2020 Dead End Water Main Elimination Package 2
Solicitation Number: CO-00419
Job No.: 20-7010

ADDENDUM 2
October 12, 2021

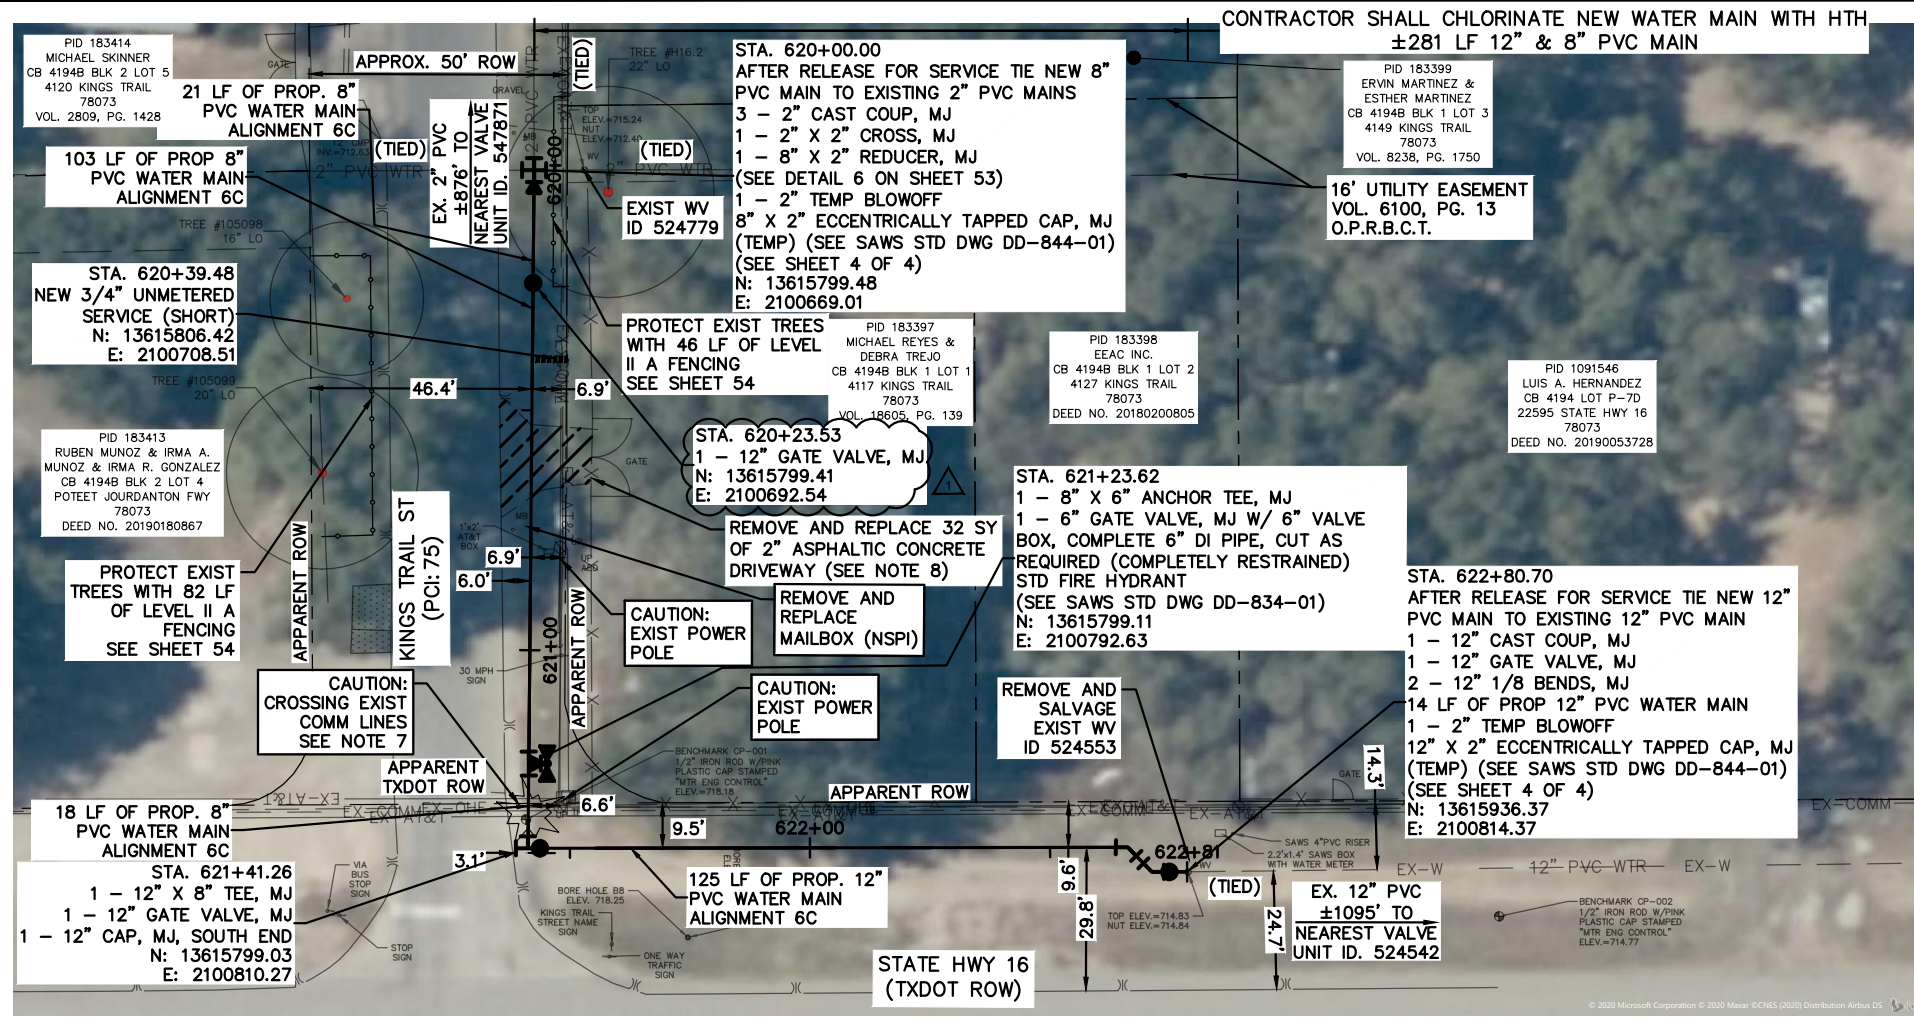
836.6 MEASUREMENT: REMOVE AND REPLACE with the following:

Ductile-Iron and Grey-Iron Fittings will be measured by their weight as listed in Table 836-1 of this specification of the various sizes of fittings installed in the field.

836.7 PAYMENT: REMOVE AND REPLACE with the following:

Payment shall be for actual Mechanical Joint fittings (AWWA) C153/A21.53 and/or flanged fittings installed in the field.
